CNRO-2006-00048

SUBJECT: Request for Alternative ANO1-PT-001
Response to a Request for Additional Information

Arkansas Nuclear One, Unit 1
Docket No. 50-313
License No. DPR-51

**REVISED FIGURES 1 AND 2 FOR
REQUEST FOR ALTERNATIVE ANO1-PT-001**

FIGURE 1

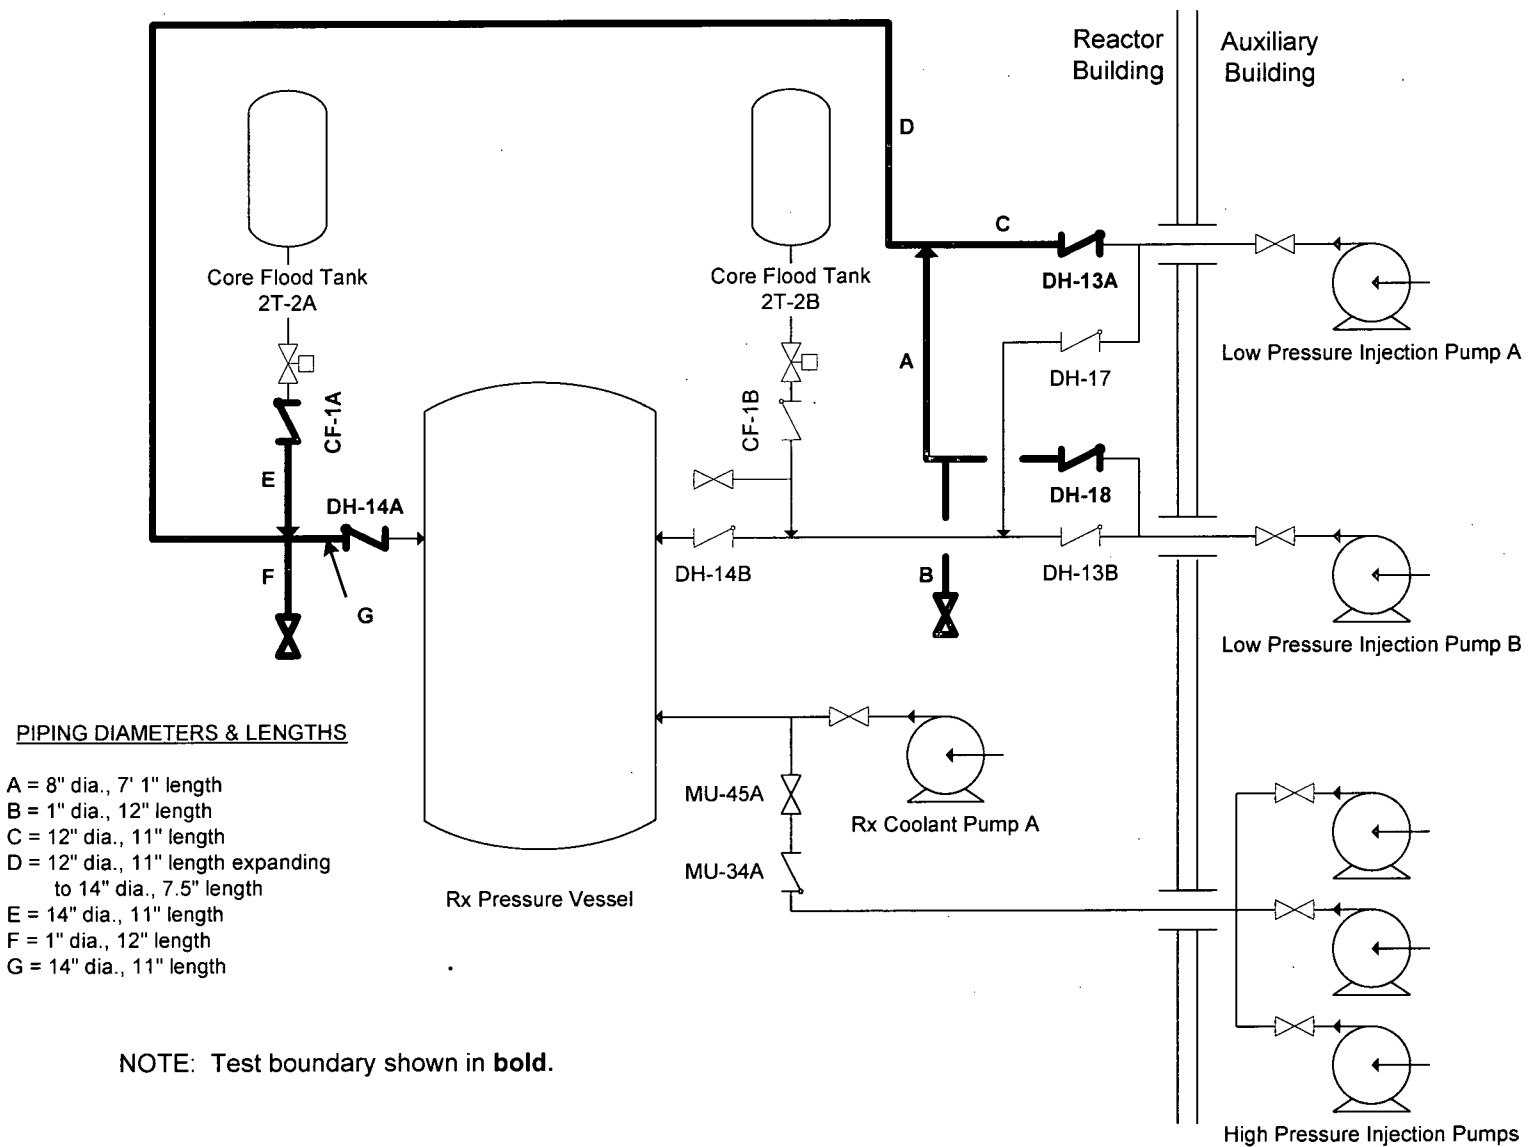
In the referenced letter, Entergy Operations, Inc. (Entergy) submitted to the NRC staff Request for Alternative ANO1-PT-001, which requests approval to visually examine the extended reactor coolant pressure boundary (RCPB) piping between the first and second normally closed isolation valves during the Class 2 system leakage test conducted each inspection interval as an alternative to ASME Section XI IWB-5222(b). In a recent telephone conversation regarding the request, the NRC requested that additional information be provided; specifically, the dimensions for the piping associated with Decay Heat Removal Loops "A" and "B".

In response to this request for additional information, Entergy has enclosed revised Figures 1 and 2 from ANO1-PT-001 that provide the requested information. These figures replace those previously contained in the referenced letter.
